Recall Bulletin

PRODUCT SAFETY RECALL

SUBJECT: Transmission Turbine Shaft Fracture

MODELS: 2012 Chevrolet Sonic
With 6 Speed Automatic Transmission (Model 6T30 - RPO MH9)
And 1.8L Engine (RPO LUW)

Proper Alignment of the (543) Low and Reverse Clutch Assembly (Zoomed In Below)

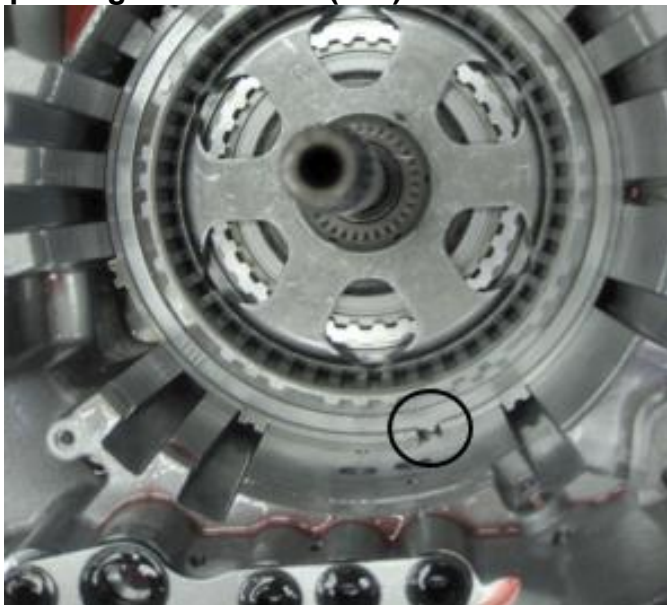
Reverse Clutch Assembly and Low and Reverse Clutch Plate Installation and Low and Reverse and 1-2-3-4 Clutch Housing, and 1-2-3-4 Clutch Plate Installation procedures in SI. Also note the photos below that show proper alignment of the (543) Low and Reverse Clutch Assembly to prevent incorrect installation and transmission damage. It is also recommended that GM technicians log on to <https://www.centerlearning.com/> and view a related training video that is found at the 40 minute mark of 10214.07D July 2014 Emerging Issues Seminar by following this path: *Resources>> Video on Demand>> Enter 10214.07D in the "Search Videos" Field >> Click on the Magnifying Glass Icon to search for the video.* For Canada technicians, this video can be viewed on the GM Centre of Learning (LMS) web site, which can be accessed via the Single Sign-on process through Global Connect. Click on the "Resources" menu option, and then select "Video on Demand," "GM Pro – Centre of Learning" and "Service Technical." The video will be in the list displayed on the page.
